# MEMORANDUM

**DATE:** NOVEMBER 28, 2019 **PROJECT:** 116132

**RE:** CLARIDGE / UNIFORM DEVELOPMENT (CU DEVELOPMENTS)  
SANITARY AND WATERMAIN SERVICING OPTIONS

**FIGURE NO. 7.1**  
PROPOSED WATERMAIN  
INFRASTRUCTURE

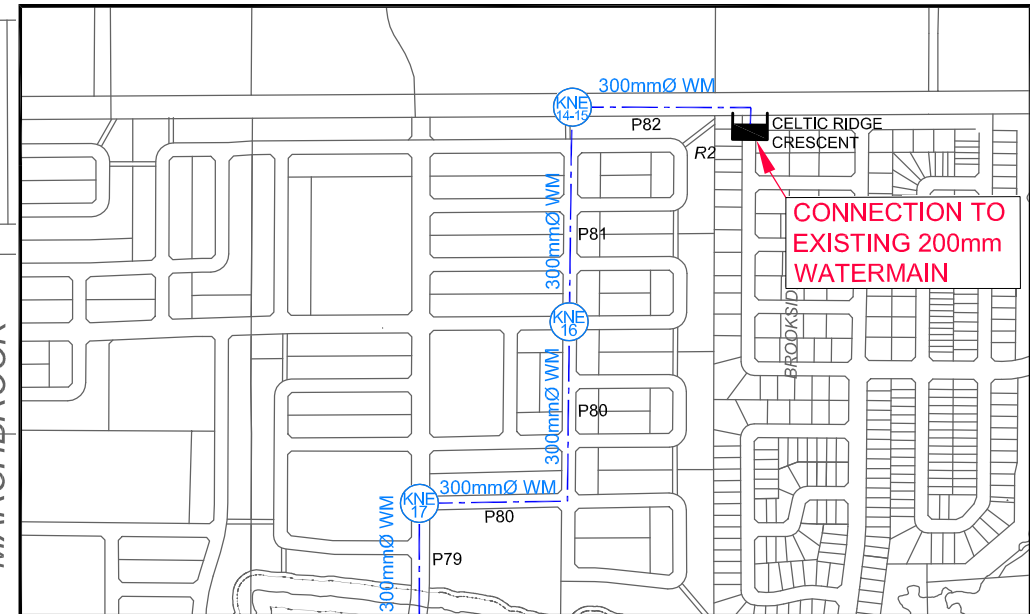
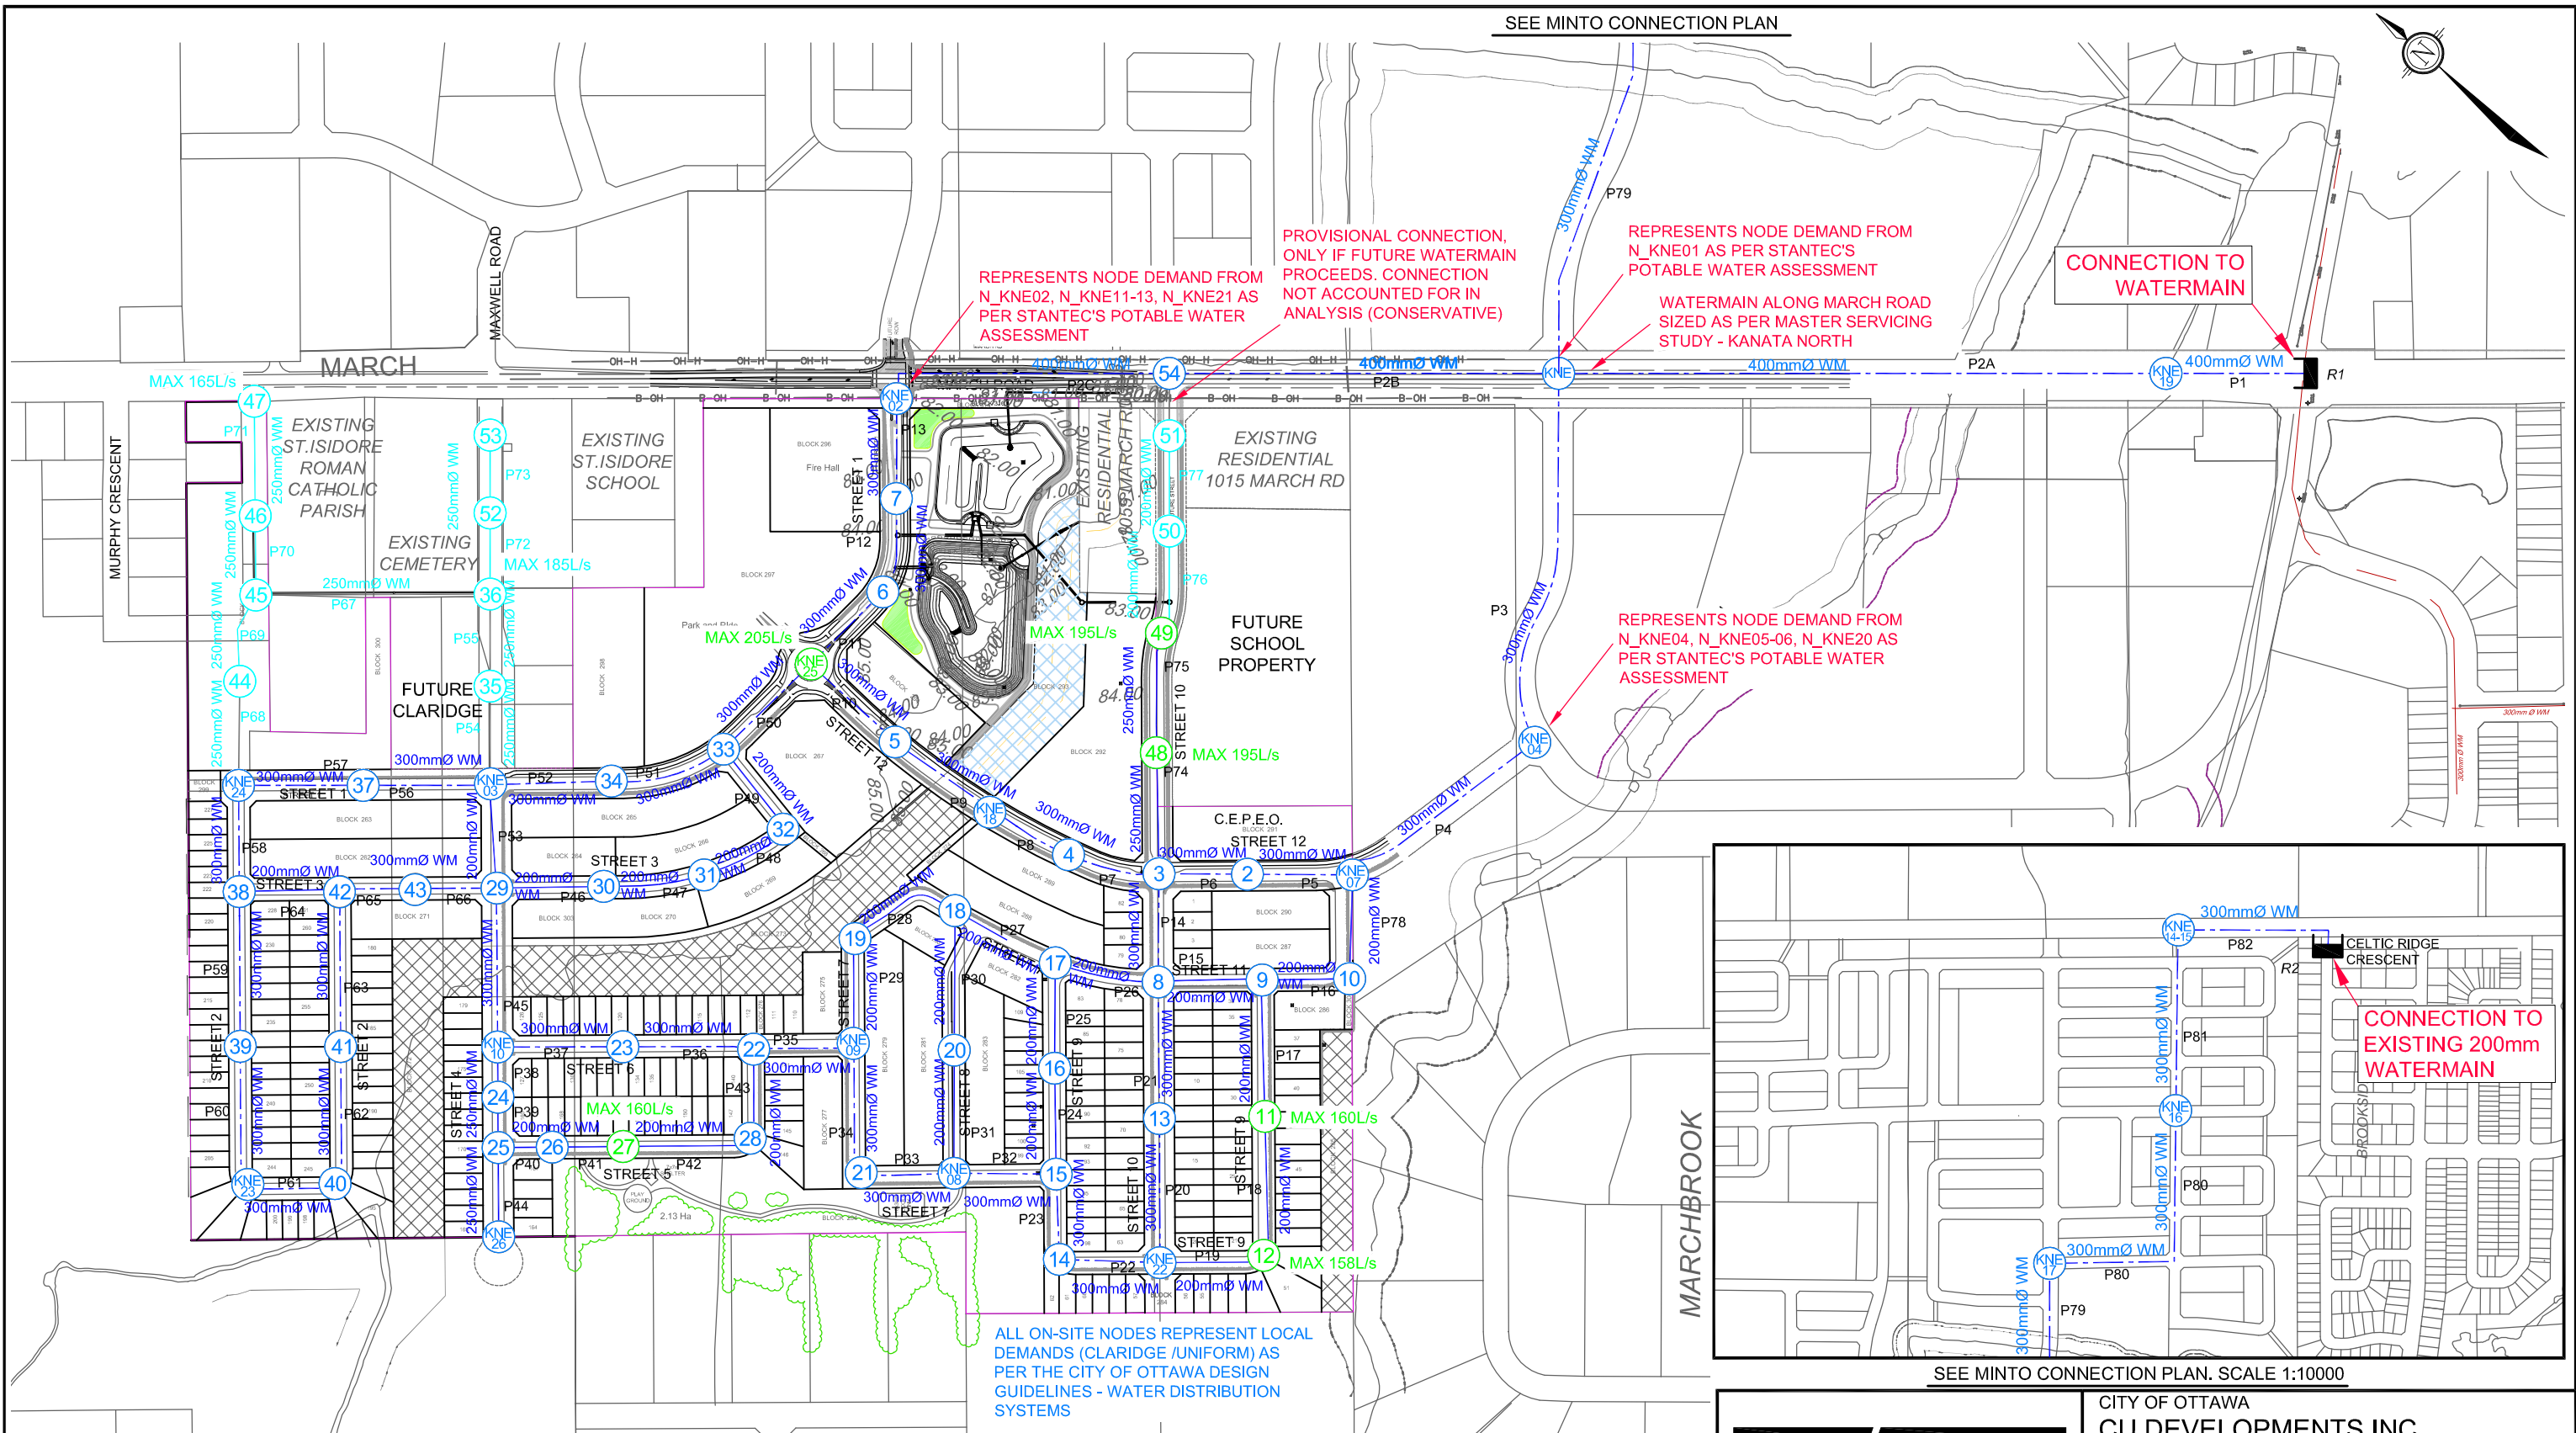
Refer to excerpt from the MSS, Figure 7.1 – Proposed Watermain Infrastructure for details.

The preferred 300mm backbone watermain layout through the CU Development lands did not extend into the existing and future development lands adjacent to March Road and the 400mm watermain extension did not reach these lands. Therefore, no preliminary layout had been established and local street watermain sizing (and layout) is to be confirmed by hydraulic modelling.

**PREFERRED WATERMAIN  
 SERVICING FOR FUTURE / EXISTING  
 LANDS**

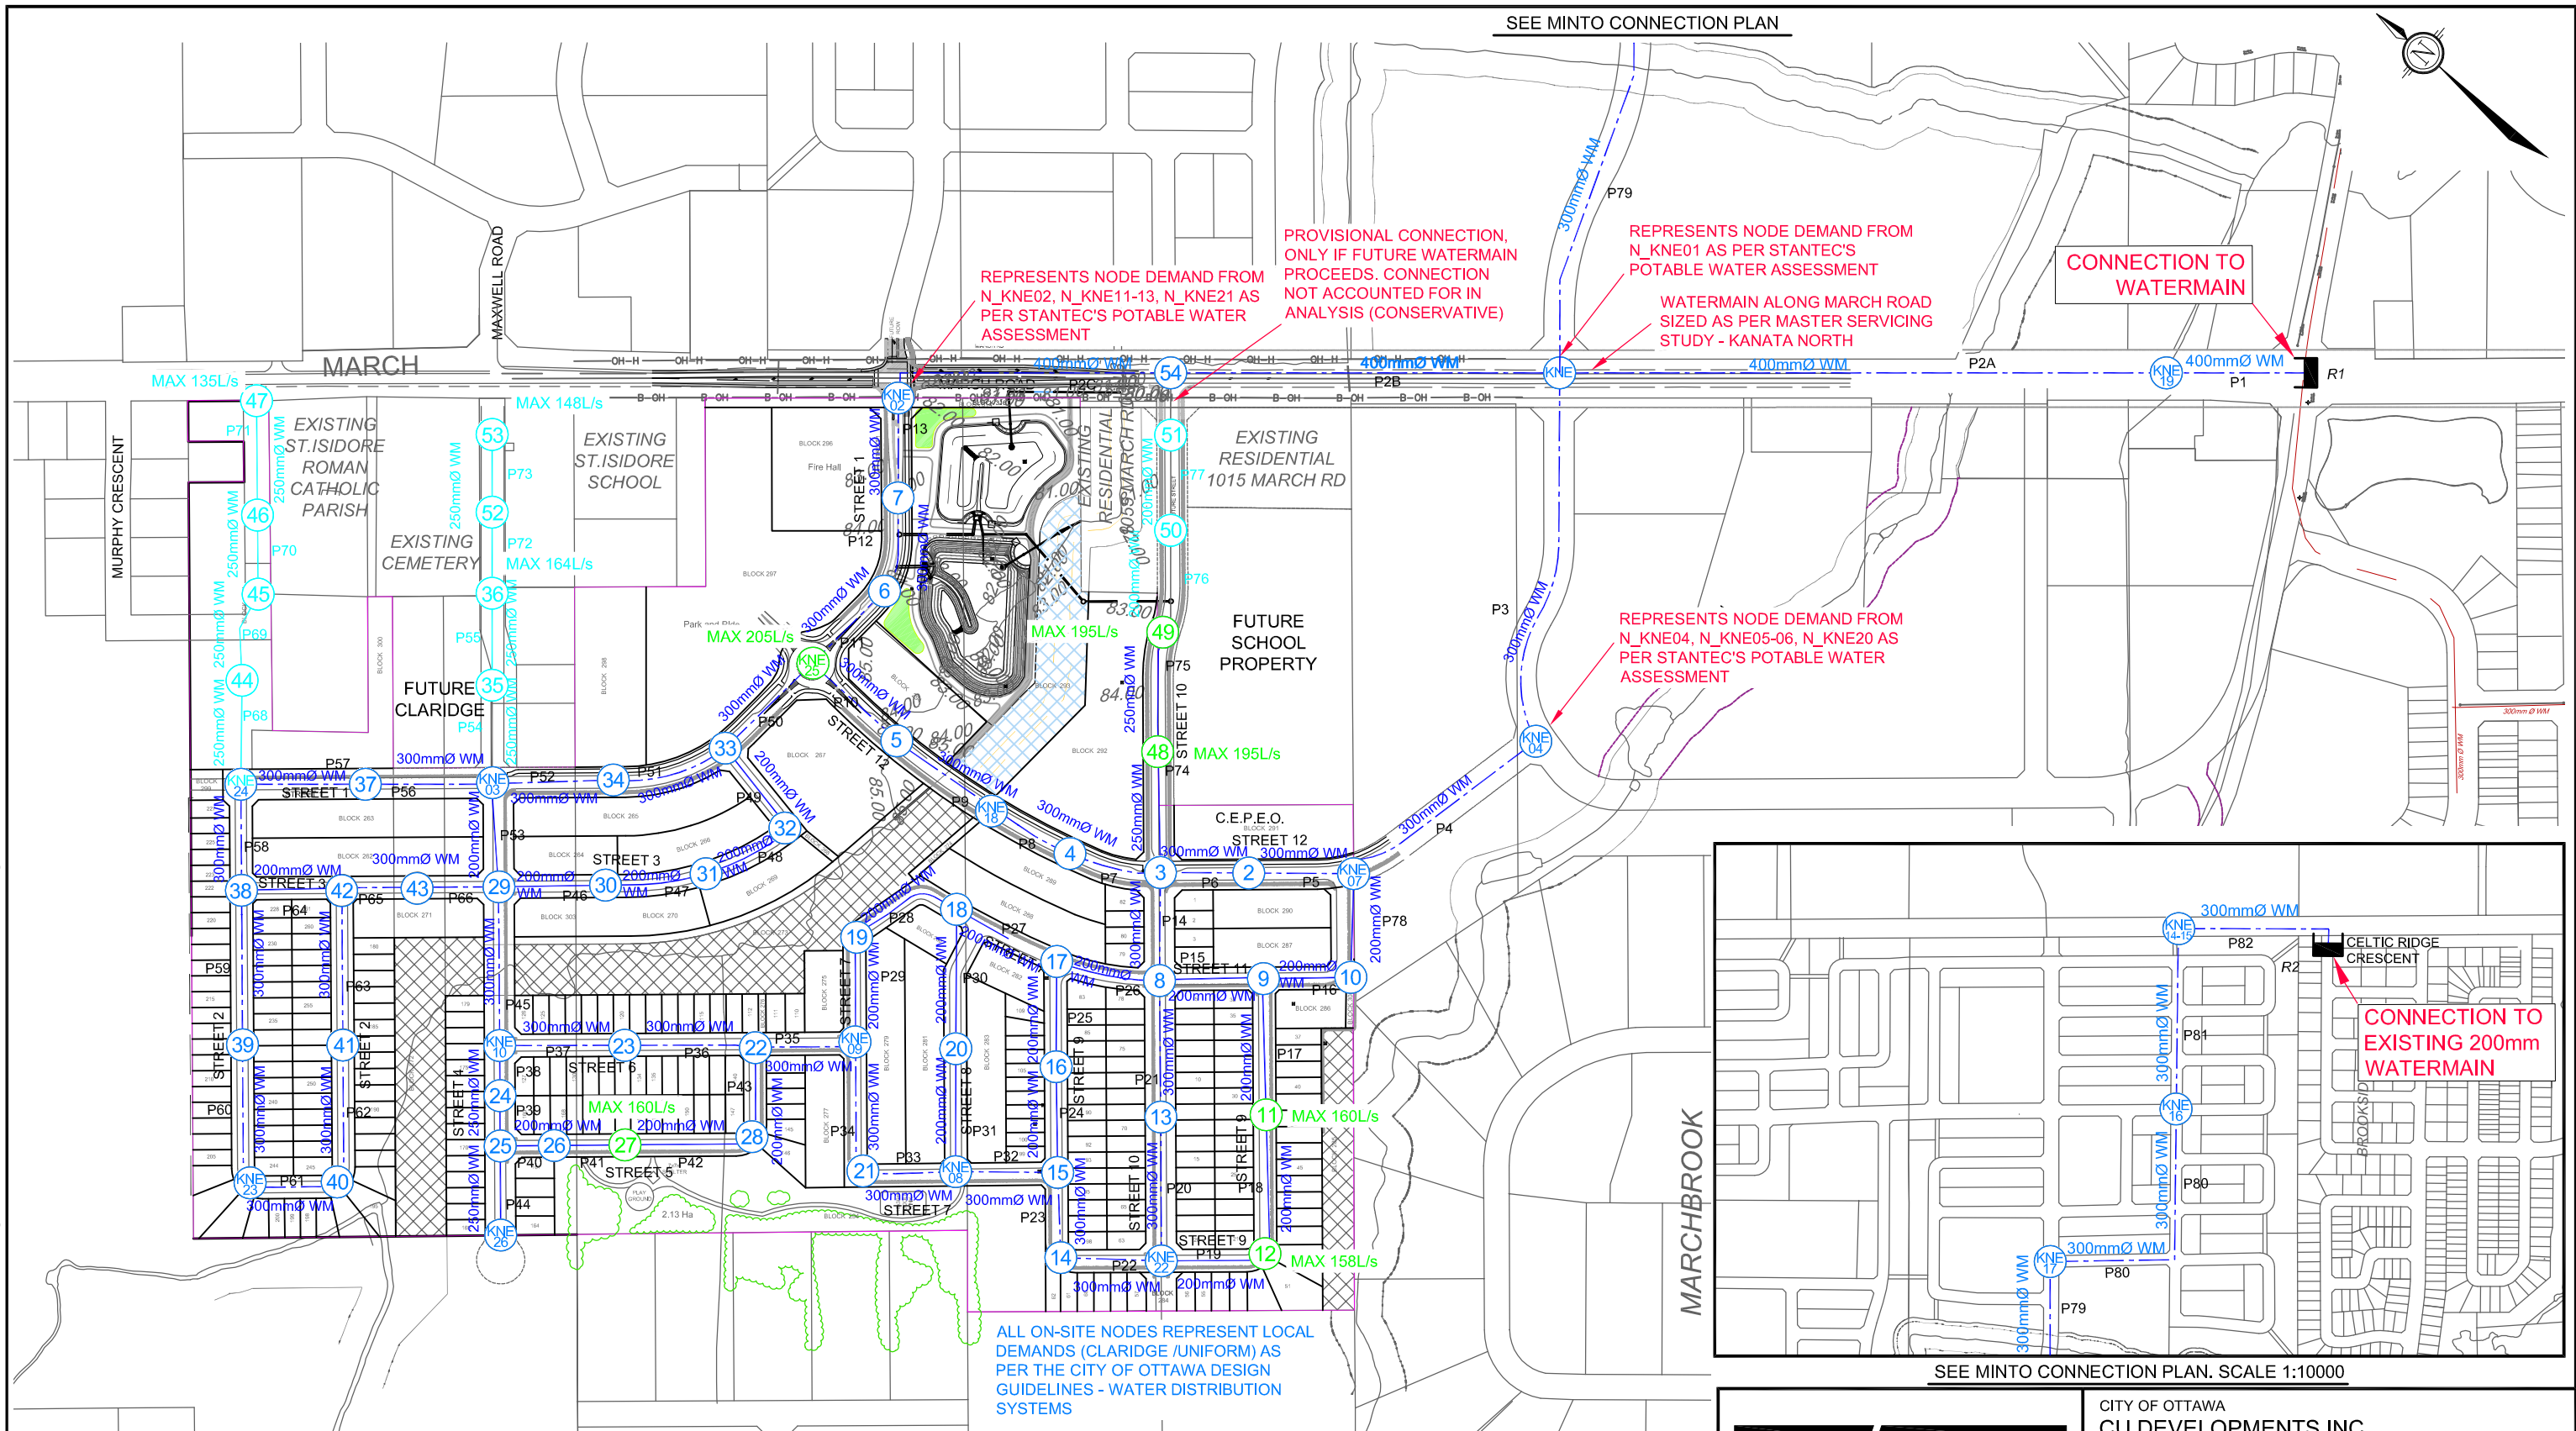
The preferred watermain servicing option for the existing and future lands is to construct a 250mm watermain through two future ROWs with a loop system between St. Isidore Church lands, cemetery lands and future Claridge lands. A 250mm watermain with a loop system minimizes headlosses and provides greater pressures and the extents of the watermain system adjacent to March Road (dead ends). The loop system is in the same location as the preferred sanitary and storm layout. Refer to Figure-WM1A – Preferred Watermain Servicing for Future / Existing Lands for details.

- 1) A maximum fireflow of 165L/s adjacent to March Road and Murphy's Court. This fireflow is considered to be a strong flow capable of servicing most residential developments.
- 2) Fireflows greater than 167L/s adjacent to the existing St. Isidore School and 185L/s adjacent to the future Claridge lands containing medium density residential blocks. Greater

Allowable fireflows under the preferred servicing strategy at the dead ends and medium density areas can be found on Figure-WM1A – Preferred Watermain Servicing for Future / Existing Lands.
